**RE: RESPONSE TO S92 REQUEST – RM230016 – SUBDIVISION CONSENT, SR & BJ
WILLIAMS CHARITABLE TRUST BOARD, WILLIAMS ROAD, MANGAKURI**

I refer to the section 92 request dated 18 September 2023. The following letter provides a response to the ten items of information requested.

Please refer to the attached letter from East Cape Consulting Ltd, dated 29 September 2023, which refers to the paths shown on the subdivision consent plan (Surveying the Bay, Drawing No. 4698-30, sheet 2, dated August 2023) as yellow dashed lines. See extract below.

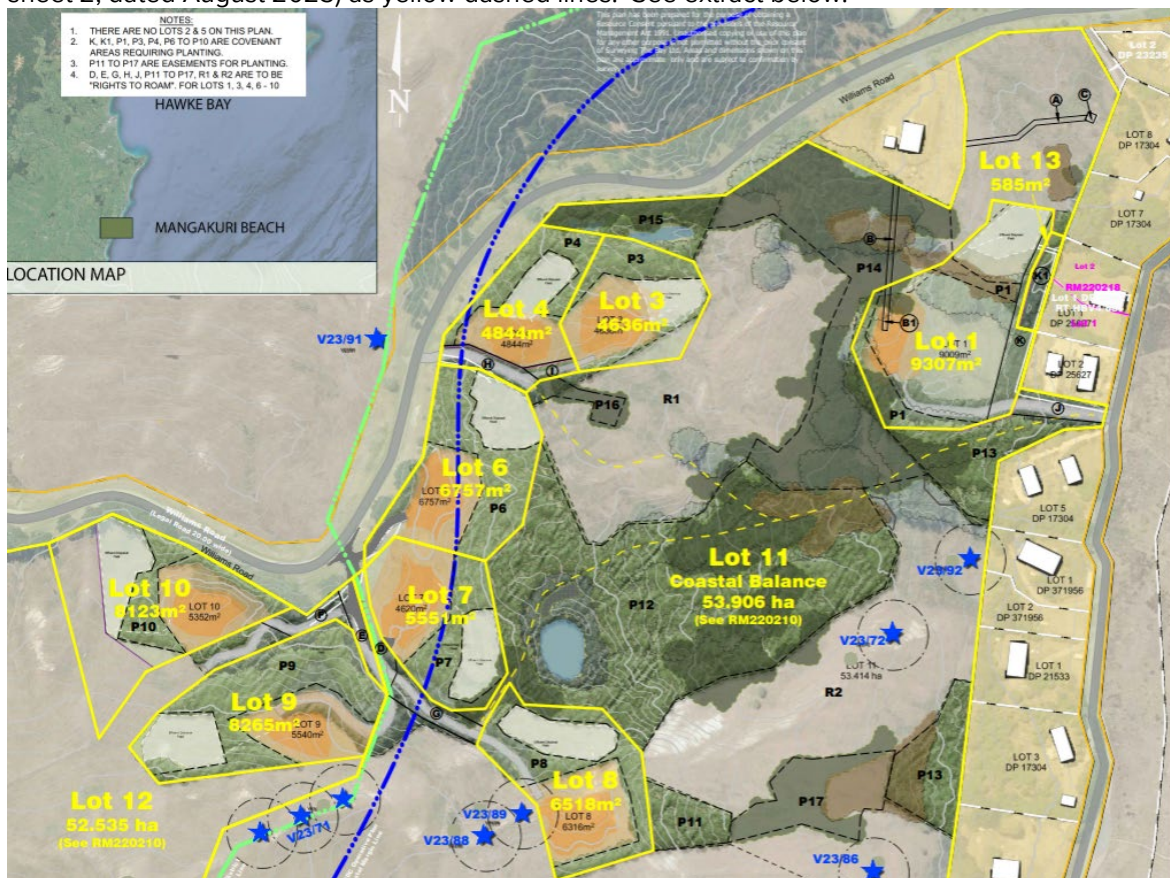
Please provide a plan of the proposed walkway path network and confirm how this will be formed and maintained on an ongoing basis.

As can be seen from the plan there are potential walkway connections from each of the three proposed vehicle rights of ways to the access onto Okura Road and the beach beyond. The paths shown are indicative and not intended to be constructed as formal tracks. The residents of each of the proposed lifestyle lots are to be conferred 'Rights to Roam' over the proposed planted and open areas of balance Lot 11 between the Right of Way to Lots 6 – 10 (the most western of the lifestyle

lots) and the Lot 1 access to Okura Road. These Rights to Roam are identified on the above-mentioned subdivision consent plan in Note 4.
